ADDENDUM #1

TITLE: Design Build Services for East Bay Bike Path Bridge Replacement

RFP #7670815 – DESIGN BUILD SERVICES FOR EAST BAY BIKE PATH BRIDGE REPLACEMENT

Per issuance of **ADDENDUM #1** the following revisions are noted:

PROPOSED SECTION BRIDGE 083751
SCALE: 1/4" = 1'-0"

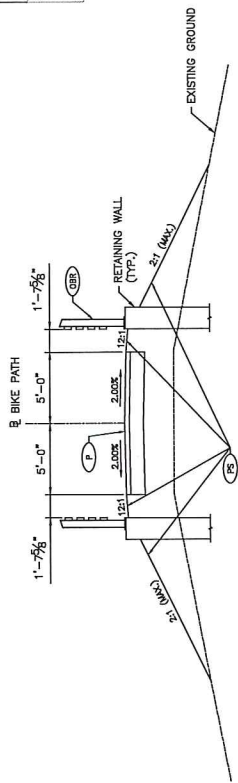
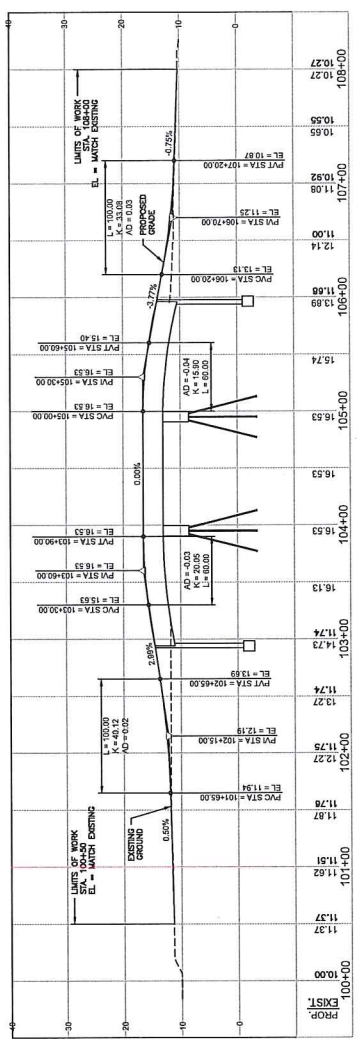
1. RFP Part 1 Revised Section 8.7.1b
2. RFP Part 2 Revised Sections 3.11.4, 3.15.1, 5.3.1.2, and 7.1.3.1
3. BTC Plans Revisions to bridge typical section sheet
4. BTC Plans Addition of temporary traffic control plans
5. Mandatory Specs Revision to Liquidated Damages

EAST BAY BIKE PATH BRIDGE NOS. 837 & 838 REPLACEMENT BRIDGE 083751 BARRETT/OWEN/REIN	
DESIGNED BY: MFW CHECKED BY: MFW DATE: DECEMBER 2021 SHEET: 1.3 OF: 23	SCALE AS NOTED REVISIONS NO. DATE BY 1. 1/15/22 BT	TYPICAL SECTION AND PROFILE

- NOTES:
1. ALL STEEL SHALL BE AASHTO ASTM 270 GRADE 50 STEEL.
 2. DIMENSIONS SHOWN ARE SCHEMATIC. FINAL DIMENSIONS TO BE DETERMINED BY THE DESIGN BUILD TEAM.
 3. TIMBER, IF USED, SHALL BE PRESSURE TREATED.
 4. FUTURE 3X3 DUCT BANK SHALL CONSIST OF THREE 6" CONDUITS OVER SIX 5" CONDUITS.
